Re: Review of EPA's Lower Yakima Valley Nitrate Study

The Yakama Nation greatly appreciates the strenuous effort on behalf of EPA and the residents of the Lower Yakima Valley towards identifying the sources of groundwater contamination and we thank you for the opportunity to provide input regarding EPA's recently published study, "Relation between nitrate in water wells and potential sources in the Lower Yakima Valley".

Figure 1

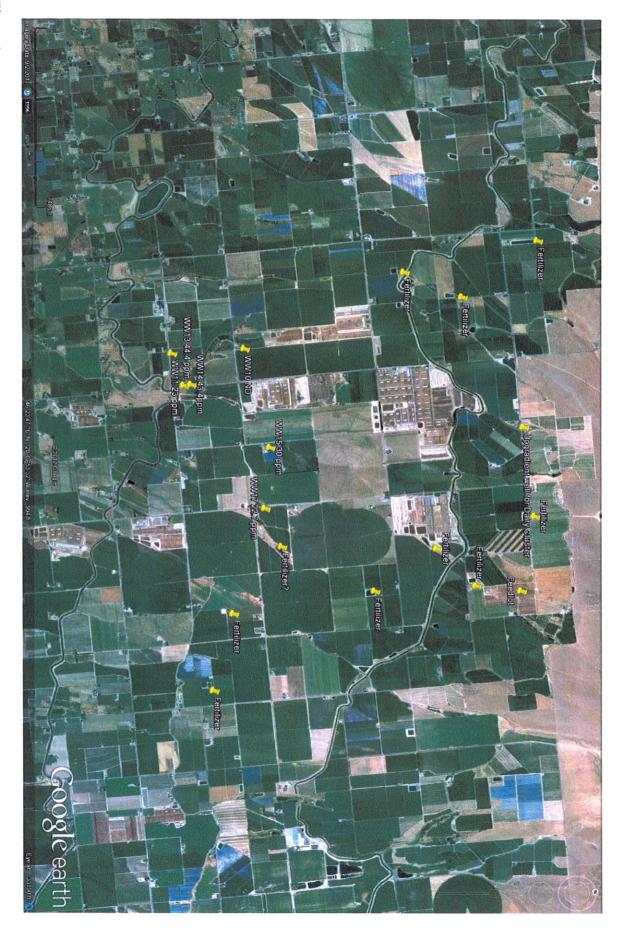
Figure 1 depicts the "Dairy Cluster" surrounded by fertigation stations for the orchards. The report states that the nitrogen source was determined to be too diffuse to accurately assess any impacts from irrigated agriculture. While the report claims that this was due in part because most of the irrigated cropland is associated with dairies either directly or indirectly through the purchasing of organic fertilizers from the dairies, the photo clearly shows that there may be significant influence from fertigation stations. The locations of the stations coupled with the presence of Tetracycline in many wells would be indicative of current orchard management practices.
